UNITED STATES PATENT AND TRADEMARK OFFICE

APPLICATION NO.	FILING DATE	FIRST NAMED INVENTOR	ATTORNEY DOCKET NO.	CONFIRMATION NO.
09/760,384	01/11/2001	Hau H. Duong	A-68718-2/RFT/RMS/RMK	2482

Office Action Summary	Application No. 09/760,384	Applicant(s) DUONG ET AL.	
	Examiner Brian J. Sines	Art Unit 1743

DETAILED ACTION

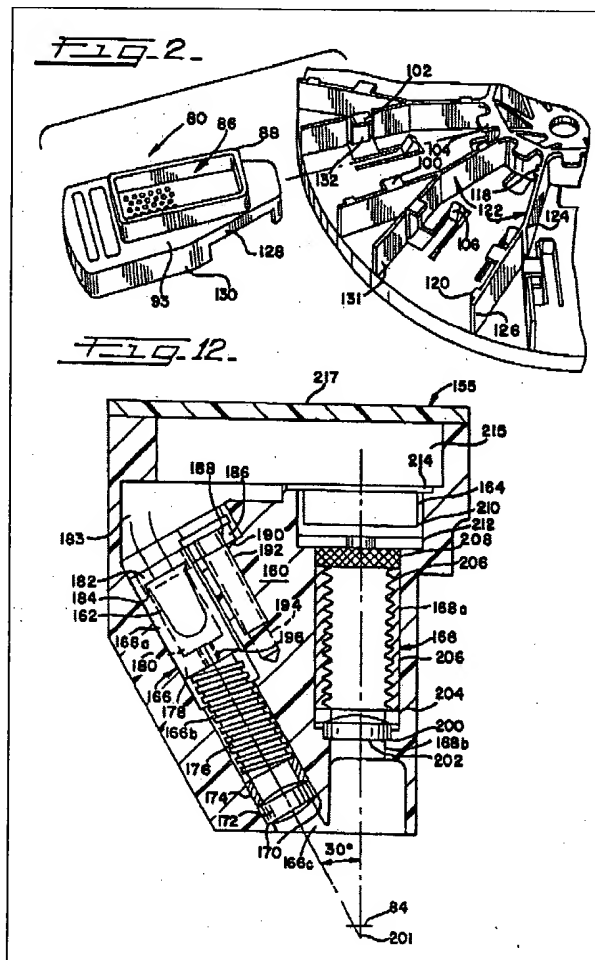
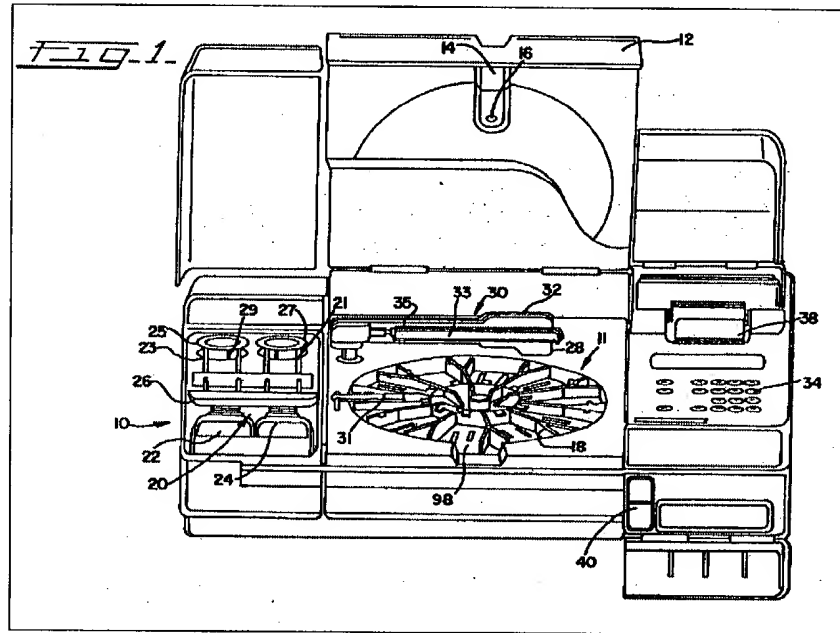
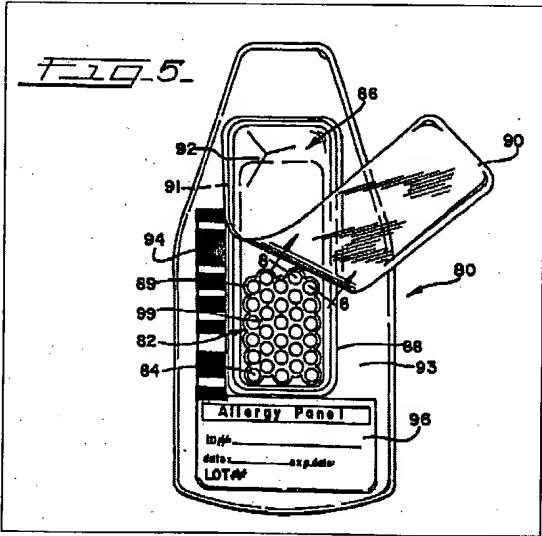
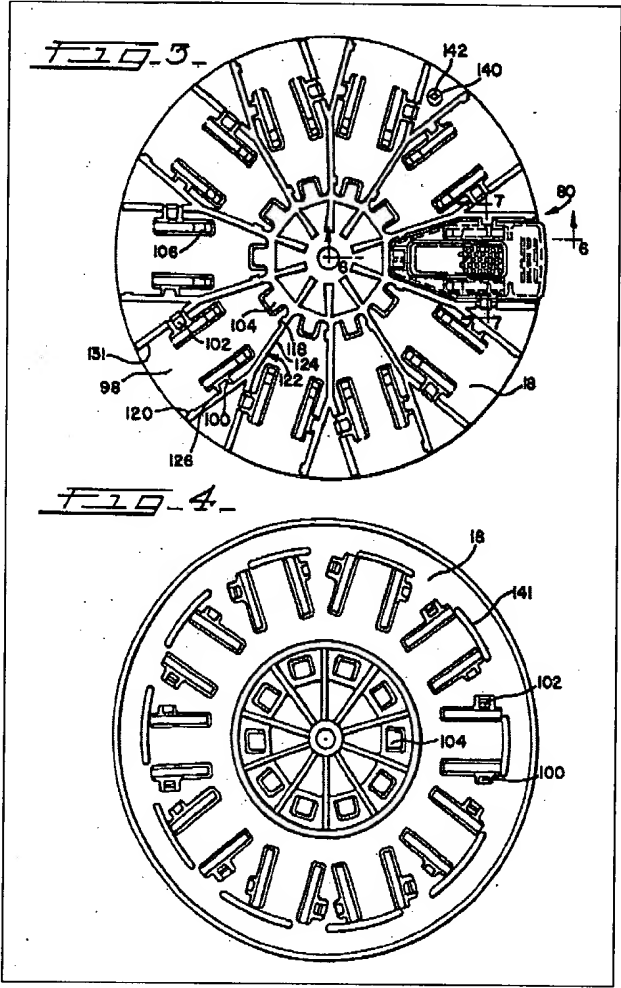
Regarding claims 24, 41 and 42, Holen et al. anticipate the recited method of analyzing a plurality of biochips, wherein the method is comprising the steps of:

(a) inserting a first biochip (reaction cartridge 80) into a first station (opening 98 on carousel 18) of an analysis device (10);

(b) inserting a second biochip into a second station of the analysis device, wherein each of the first and second biochips comprise a substrate (test card 82) comprising an array comprising a plurality of test sites (84), wherein each test site (84) is comprising:

(c) detecting the presence of the label on the first biochip utilizing optical reader (32) from the test sites (84) from the reaction cartridge (80); and

(d) detecting the presence of the label on the second biochip (see col. 6, line 10 – col. col. 20, line 38; figures 2, 3 & 5).
